Service Bulletin

Bulletin No.: 17-NA-140

Subject: Rattle Noise from Rear of Vehicle and/or Wind or Buffeting Noise While Driving with One Window Lowered

Brand:	Model:	Model Year:		VIN:		Engine:	Transmission:
		from	to	from	to		
Chevrolet	Camaro	2016	2020			All	All

4773146

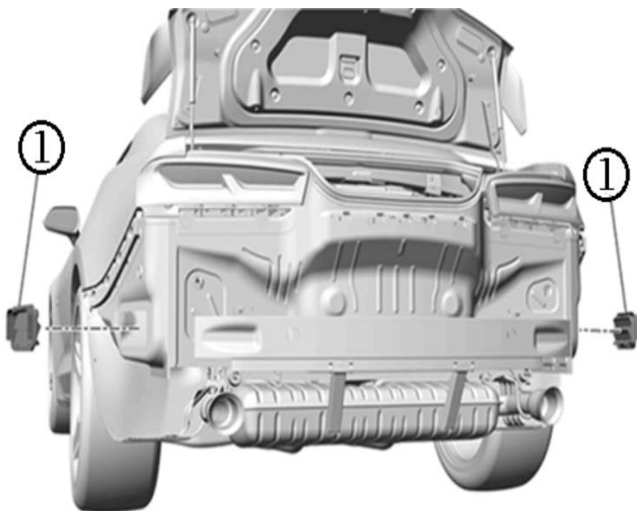
For vehicles exhibiting this condition, replace both of the original body pressure relief valves (1) with two of the four-flap design valves listed in the Parts Information table. Refer to *Body Pressure Relief Valve Replacement* in SI.
